Tweed Valley Hospital Development

Addendum 2 to Design Report

Issued for: State Significant Development Application – Response to Submissions

130559-BON-CIV-RPT-007

EXISTING MUSIC CATCHMENT PLAN

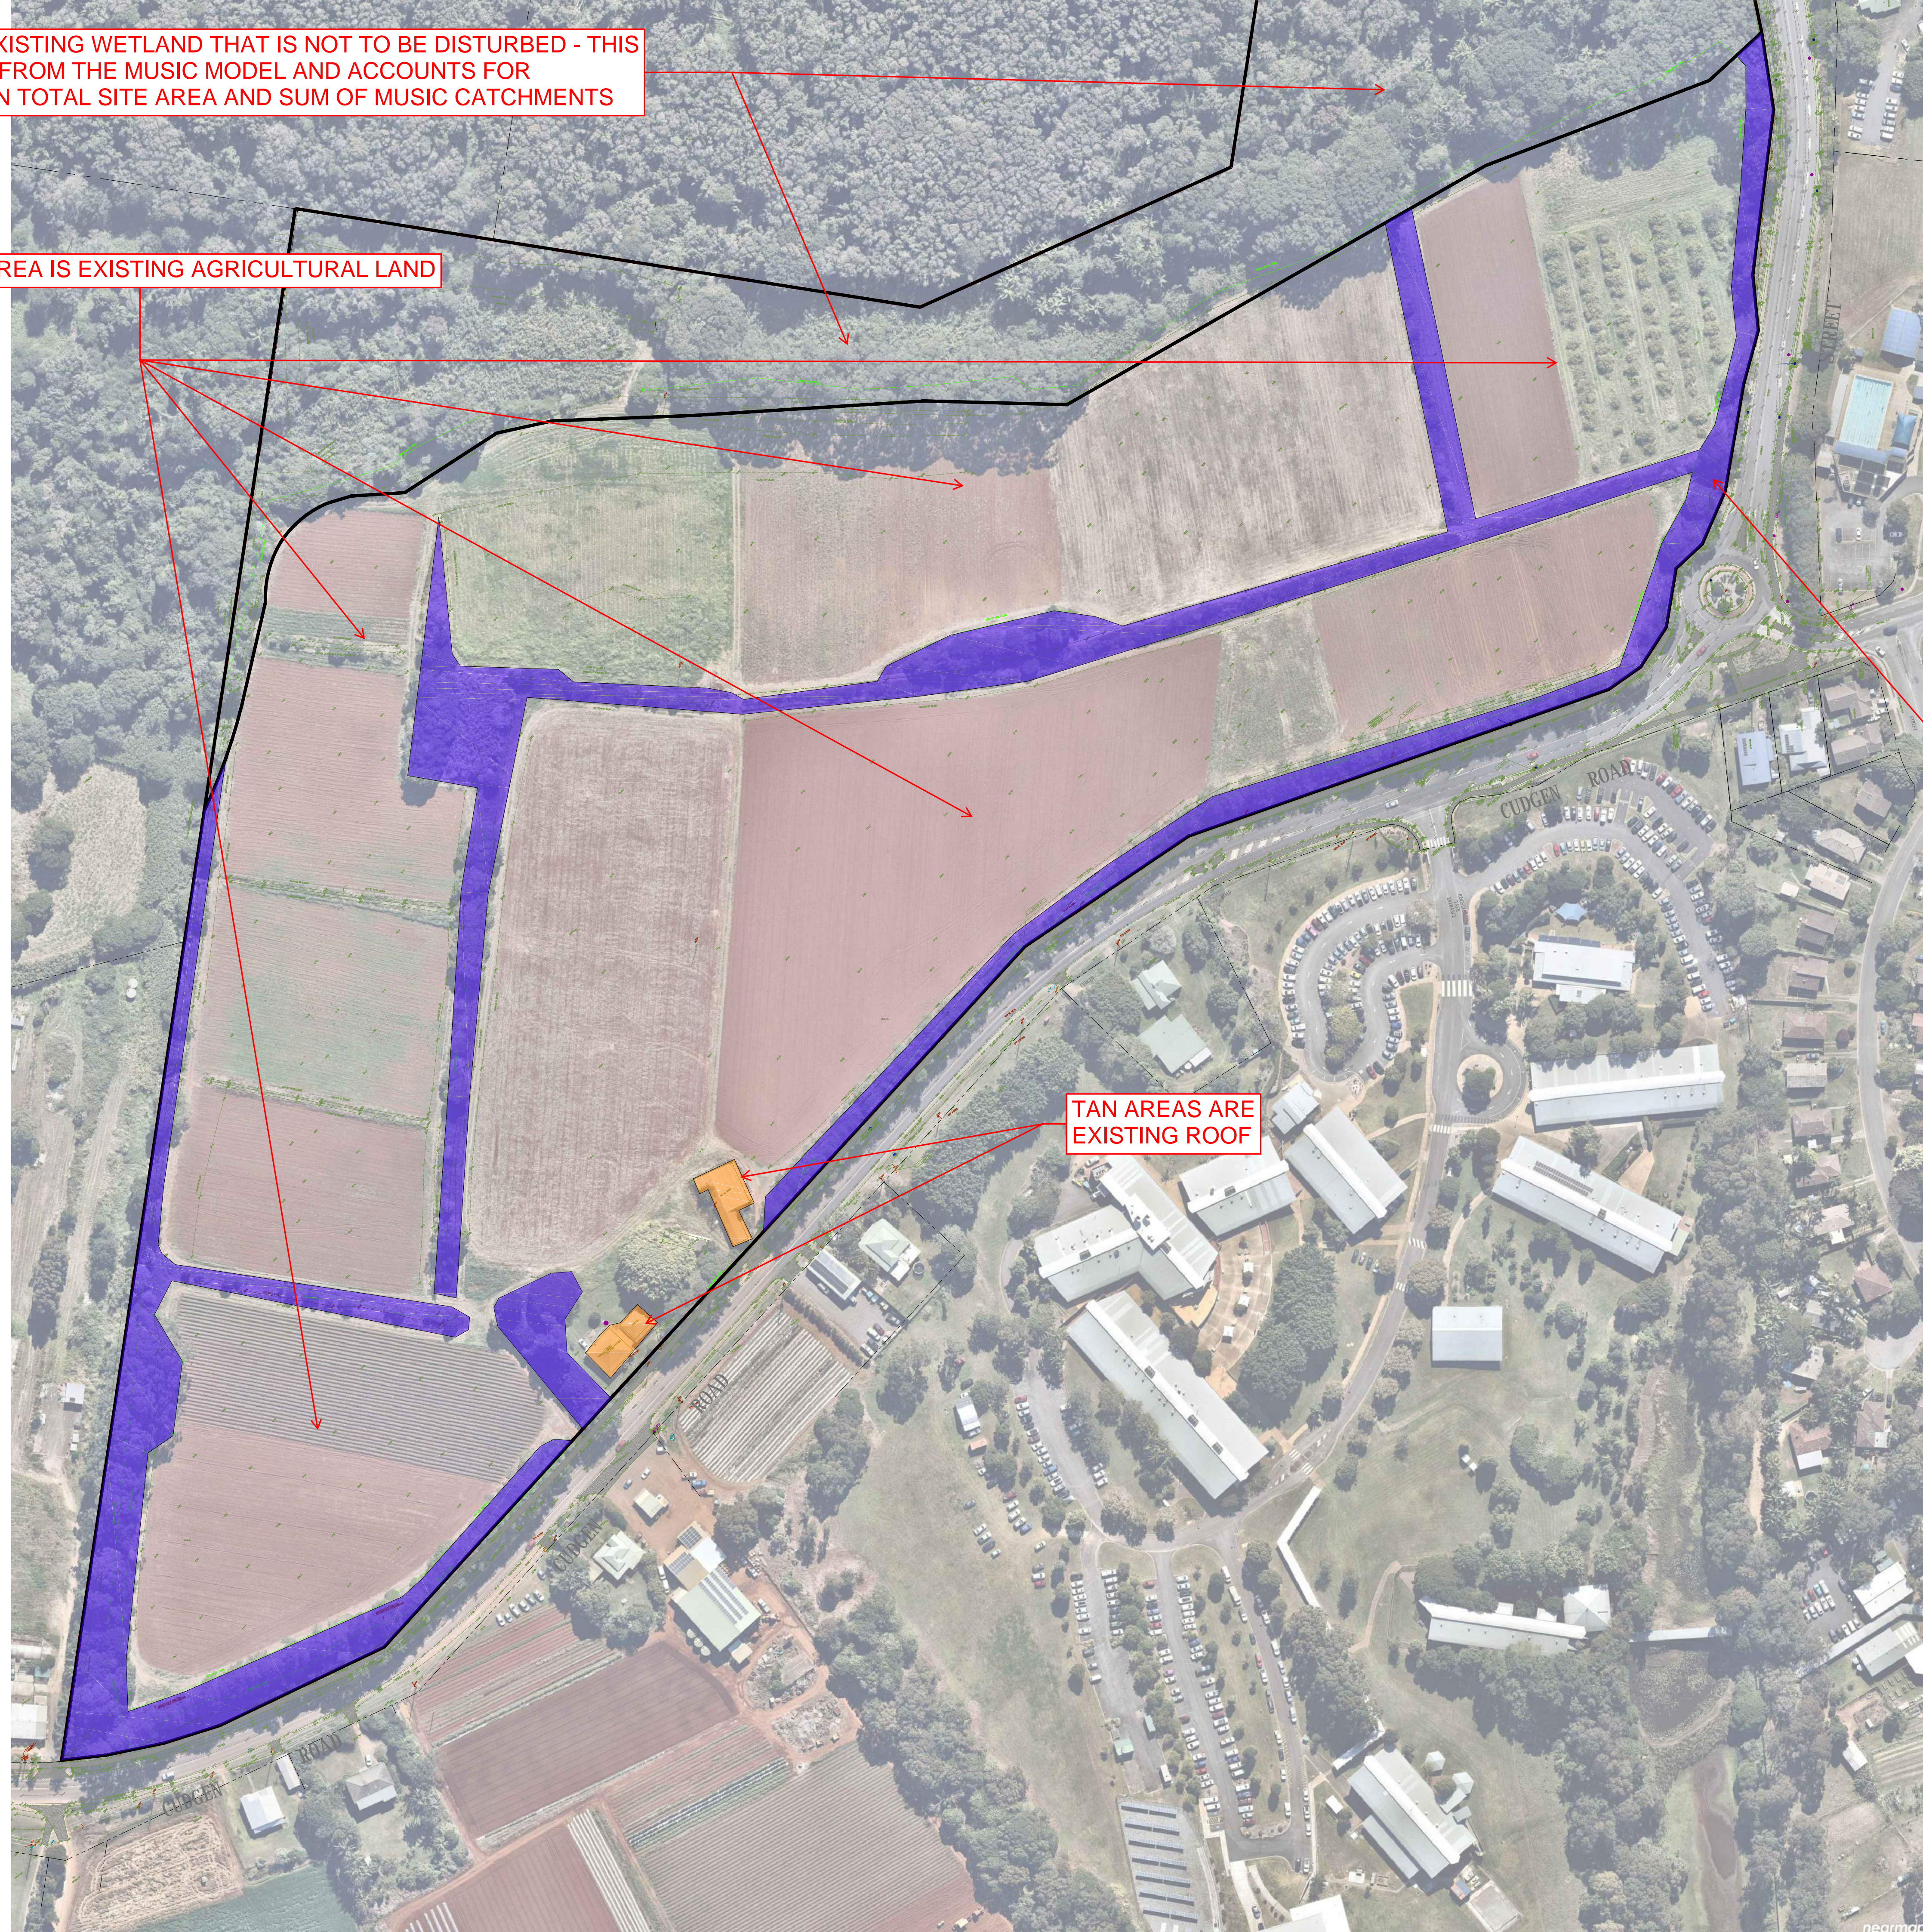
Total catchment area – The total site areas modelled for the pre-development and post development condition were 17.04 ha and 19.68 ha. These areas should be the same to enable the treatment performance of the strategy to be compared. The total site area modelled also differs to that presented in Table 4-1 of the Design Report (i.e. 23.23 ha). The correct catchment area should be confirmed, and the models adjusted accordingly.

Land uses – The pre-development land uses adopted for the site primarily comprise forest and agricultural areas. The estimated areas modelled for each of these land uses appears different to that suggested by recent aerial imagery.

- Updated MUSIC catchment plans have been provided. Total MUSIC catchment area is 16.25ha for both pre and post. The difference in site area is explained in the catchment plans (attached) – it reflects the fact that the northern portion of the site is existing wetland, that is not to be changed. This area is excluded from the MUSIC model as it does not drain to any of the catchment areas nor is it to be changed as part of the proposed development.

- Updated MUSIC catchment plans have been provided. Total MUSIC catchment area is 16.25ha for both pre and post. See attached catchment plans for pre and post areas – the areas have been based on aerial photo, site survey and inspection.

NORTHERN AREA IS EXISTING WETLAND THAT IS NOT TO BE DISTURBED - THIS HAS BEEN EXCLUDED FROM THE MUSIC MODEL AND ACCOUNTS FOR DIFFERENCE BETWEEN TOTAL SITE AREA AND SUM OF MUSIC CATCHMENTS

PURPLE AREAS ARE EXISTING "FOREST" FROM SURVEY, SITE INSPECTION AND AERIAL PHOTO. THIS INCLUDES REMNANT VEGETATION THAT IS NOT BEING USED FOR AGRICULTURAL PURPOSE

GREY AREA AND AREA TO NORTH OF ROAD IS REVEGETATED LAND - NORTHEAST PORTION BYPASSES BIO-RETENTION (2.577Ha)

LIGHT PURPLE AREA IS REMNANT FOREST - NORTHEAST PORTION BYPASSES BIO-RETENTION (0.202Ha)

DARK PURPLE AREA IS ROADS/CARPARK THAT IS DIRECTED TO BIO-RETENTION (4.349Ha).

WHITE AREA IS REVEGETATED LAND THAT IS DIRECTED TO BIO-RETENTION (6.648Ha). NOTE THAT THIS IS NOT 100% IMPERVIOUS TO ALLOW FOR PAVED AREAS TO FRONT OF HOSPITAL, PATHS ETC

TAN AREA IS ROOF AREA THAT IS DIRECTED TO BIO-RETENTION (2.313Ha). NOTE THAT THIS IS ENVELOPE AND ROOF AREA IS ACTUALLY LESS THAN THIS
